911 Address 178 SW Creekside Lane, L.C. FL 32024

From: The Columbia County Building & Zoning Department
Plan Review
135 NE Hernando Av.
P.O. Box 1529
Lake City Florida 32056-1529

Owner Darryl Allen Contractor Concept Construction
On the date of July 24, 2006 application 0607-46 and plans for construction of a single family dwelling were reviewed and the following information or alteration to the plans will be required to continue processing this application. If you should have any question please contact the above address, or contact phone number (386) 758-1163 or fax any information to (386) 754-7088.

To help ensure compliance with the Florida Residential Code 2004 the comments below need to be addressed on the plans.

Application for Onsite Sewage Disposal System Construction Permit. Part II Site Plan

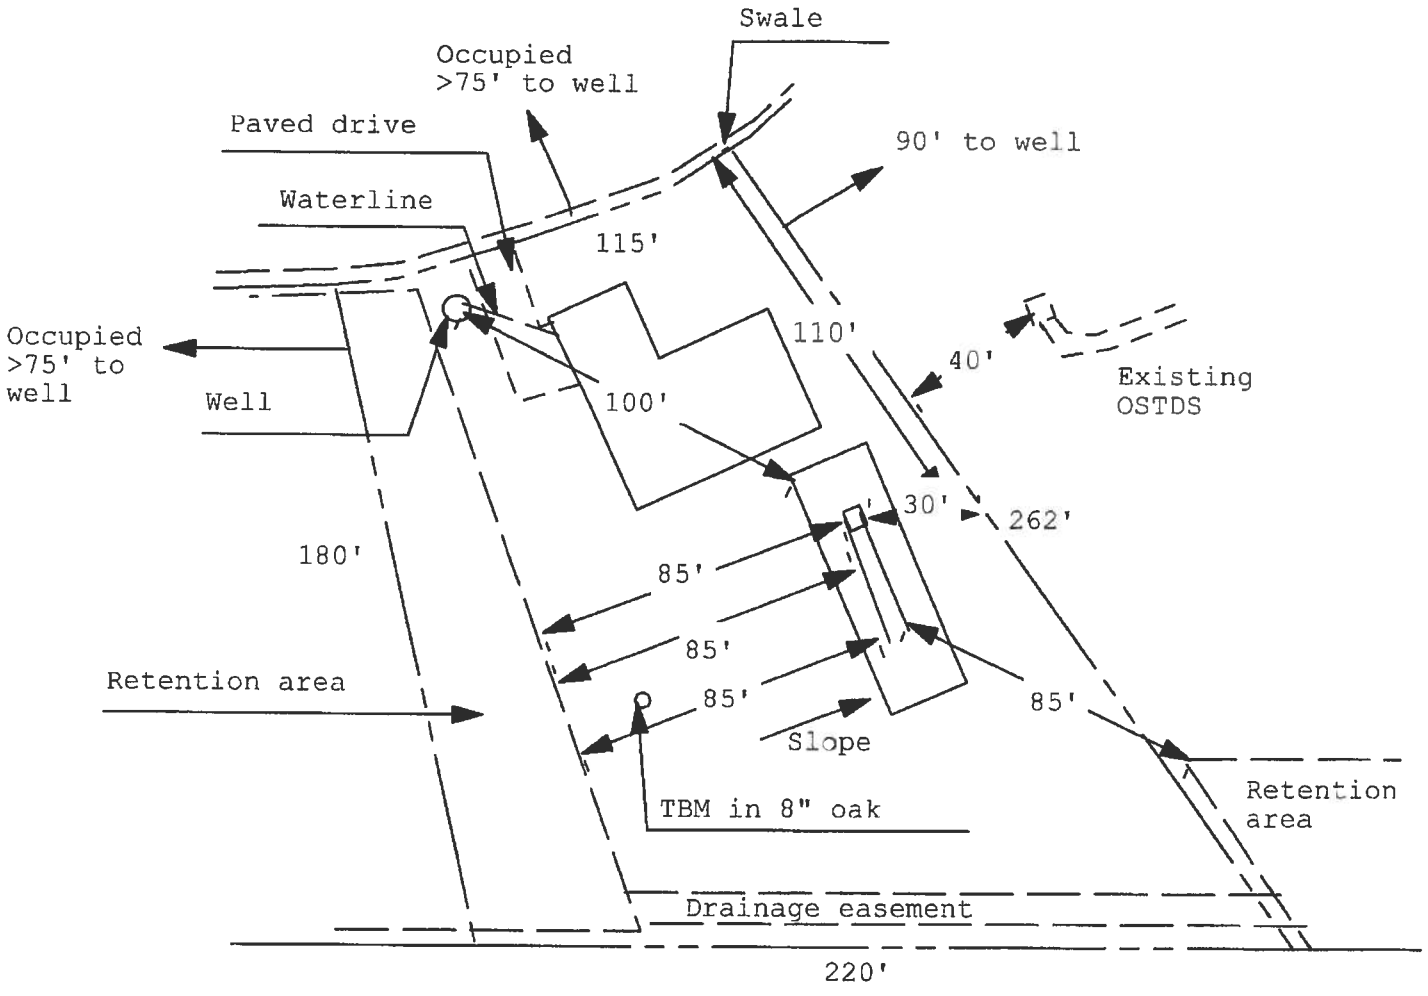
3. Please provide a copy of a signed released site plan from the Columbia County Environmental Health Department which confirms approval of the waste water disposal system.

4. Please submit a site plan which the actual distance of the structure from the property boundaries on the application and the submitted site plan showing the location of the structure coincide with each other.
